## Motor wiring inversion on certain batches

This errata sheet applies to the counter clockwise motors of some batches of the STEVAL-DRONE01 kit, identified by the STEVAL-FCU001V1 flight controller unit lot 2419.

**Figure 5. STEVAL-DRONE01 - motor positioning and rotation sense (or direction)**

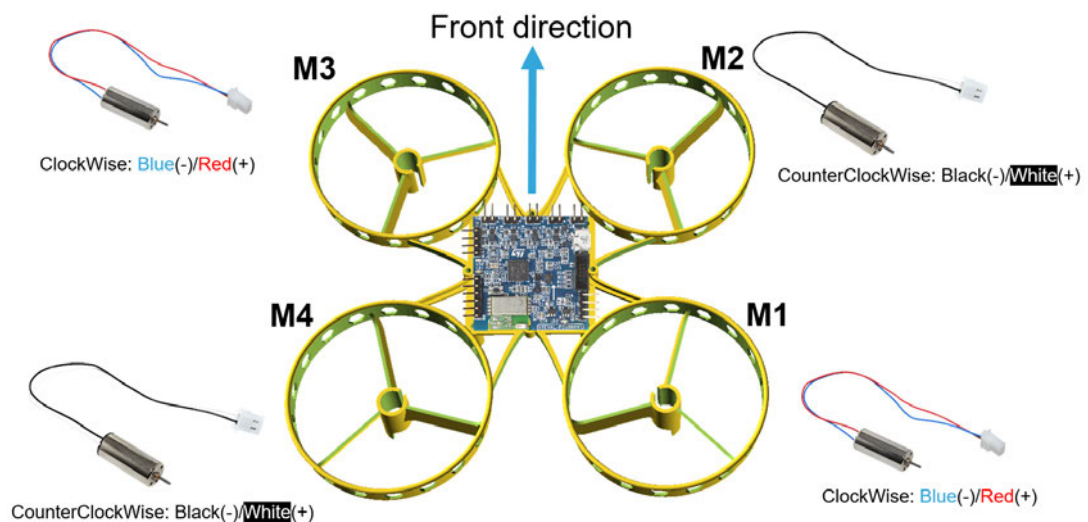
1. check the white connector of the CCW motors (the correct ones have the flat side as in [Figure 4](#))
2. check the effective rotation of the four motors and compare it with the figure below; in particular, check whether M2 and M4 can rotate in counter clockwise mode.

Figure 6. STEVAL-DRONE01 motor connection - standard case

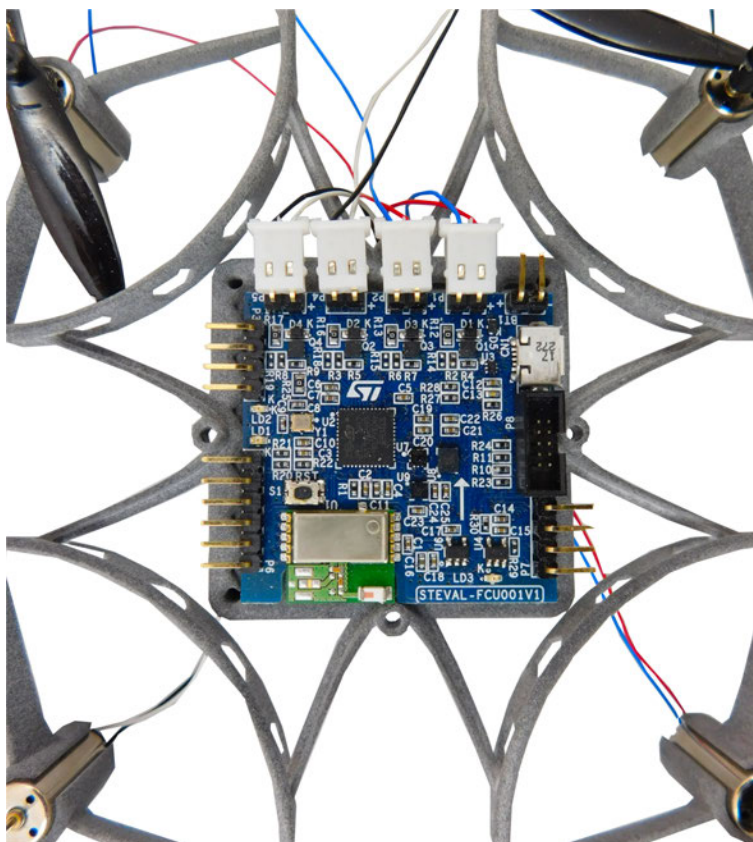
If M2 and M4 rotate in clockwise mode and the motors have been connected as shown in [Figure 6](#), this means the motors have the wrong wiring connection.
